**Re: Response to Agency Comments on Soil and Water Report, The Next Generation, Energy From Waste Plant, Eastern Creek.**

I have reviewed the relevant comments and have addressed those relevant to the Edison Environmental & Engineering (Edison) report entitled *Assessment of Soil and Water Impacts: Proposed Energy from Waste Facility, Eastern Creek (E15002-DADI-001)* herein.

This letter provides a response to comments from: Environment Protection Authority of New South Wales (EPA NSW with EnRisk and Arup); Blacktown City Council; and Hanson.

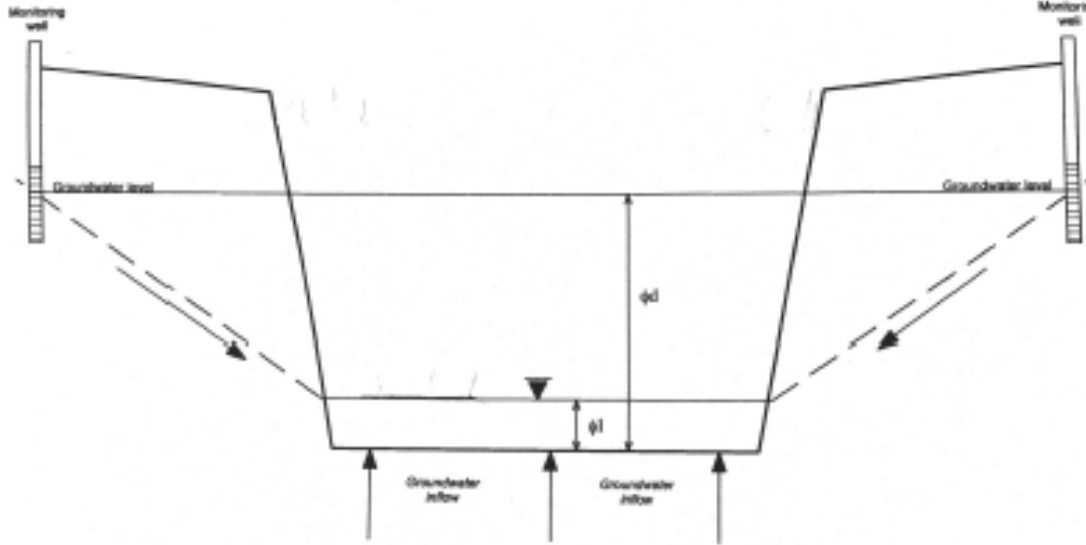
Letter	<p>Inadequate Groundwater Impact Assessment. Insufficient detail provided in the EIS on the nature of the waste bunker to adequately assess true impacts on the groundwater system that flows through to Ropes Creek and potential GDEs and IDEs.</p> <p>“The waste bunker, some 15m deep, has the potential to intercept and possibly obstruct</p>
--------	-----------------------------------------------------------------------------------------------------------------------------------------------------------------------------------------------------------------------------------------------------------------------------------------------------------------------------------------------------

The volume of inflow through the base of the bunker (assuming no confinement) can be estimated using equations derived by Haitjema (1992). A schematic diagram showing the relationship of the input parameters is presented in the figure below. The following model was adopted:

$$Q = K ((\Phi d - \Phi l) / \Phi d) A$$

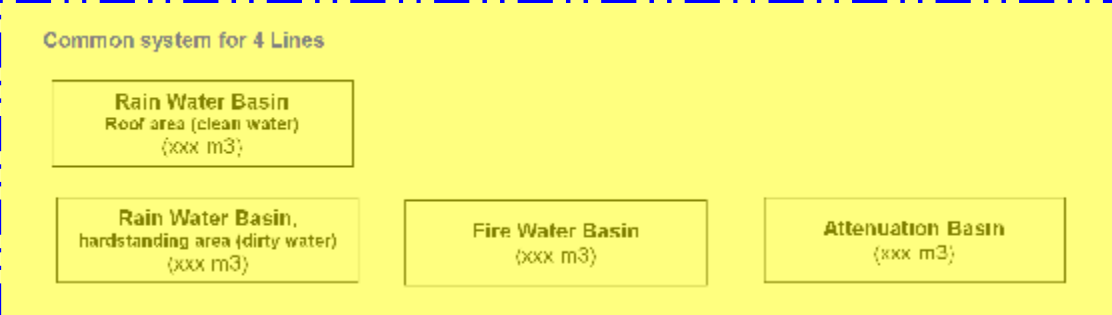
- a. The overall water consumption is nominated as 25.6 m/h (Concept Design pg 25), but no breakdown is provided. It is assumed that the water treatment plant effluent and the boiler blow down volumes will be consumed by ash quenching. Therefore the wastewater will be disposed with the bottom ash in evaporation and absorption (bottom ash 25% H<sub>2</sub>O by weight). The wet bottom ash is proposed to be recycled as aggregate, however water may degrade the value of the aggregate.

- d. No water balance is provided, which is essential to determine how water is used and reused within the plant. The Soil and Water Report Section 7.2 and EIS Section 3.16 deal with water only at a high level for the actual power plant.

Response: The plant designer, Inova HZI has prepared a water balance for the plant (attached). The water balance provides a detailed account of water use in the plant. The water balance shows the amount of water expected to be use for ash quenching but does not estimate the water content of the quenched ash.

Response: Plant designer Inova HZI prepared the water balance for the plant (attached). The water balance provides a detailed account of water use in the plant.

Schematic Cross Section with Existing and Predicted Groundwater Pressure Surfaces

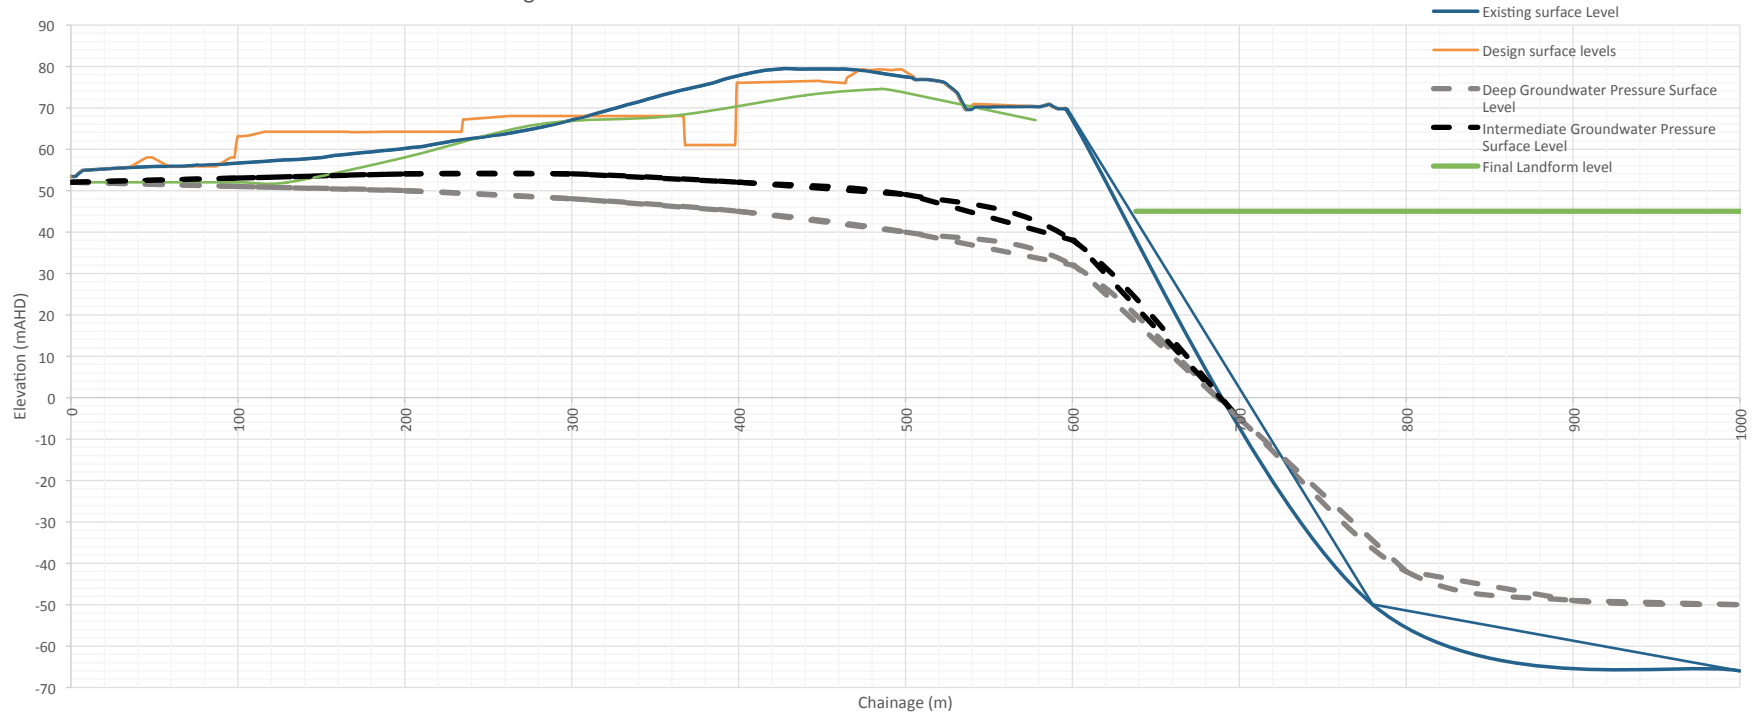
<p>shallow groundwater flow. As no significant groundwater is expected to be encountered at the proposed excavation depths, the potential impacts are considered to be negligible.”</p> <p>Figure 3.6 of this report shows the location of groundwater monitoring bores (piezometers) within the vicinity of the proposed development. Table 3.3 of this report states that the depth measured to ground water at these bores:</p> <p>It is evident that the proposed invert of the waste bunker will be significantly lower than the existing groundwater levels. There is insufficient detail provided in the EIS on the nature of the waste bunker to adequately assess true impacts on the groundwater system that flows through to Ropes Creek and potential GDEs and IDEs. According to the BOM GDE and IDE mapping (below) the area in question is highly likely to have ground water interaction and have GDEs and/or IDEs reliant on surface and subsurface ground water flows. The EIS has made no assessment of the impacts on these GDEs and IDEs.</p>

A cross section of the site showing the current and proposed land surface, intermediate and deep groundwater pressure levels and interpreted shallow groundwater table is attached. The data herein are derived from IGGC (2014). The location of the cross section is shown in the attached plan prepared by AT&L.

It is noted that:

- The existing ground surface at the location of the proposed waste bunker ranges from ~74 to ~78m AHD;
- The level of the base of the waste bunker is ~61 mAHD;
- The interpreted shallow groundwater table at ~68-70 mAHD (IGGC, 2015);
- The completed width of the waste bunker is approximately 32 m.

It is understood that the waste bunker will be fitted with a groundwater drainage and extraction system, presumably comprising drainage material between the excavated bedrock and concrete liner.

It is expected that, over time, the shallow groundwater table will be depressed in the area around the waste bunker. Groundwater inflows are expected to be greatest immediately following completion of the excavation and then progressively decline as water until levels stabilise.
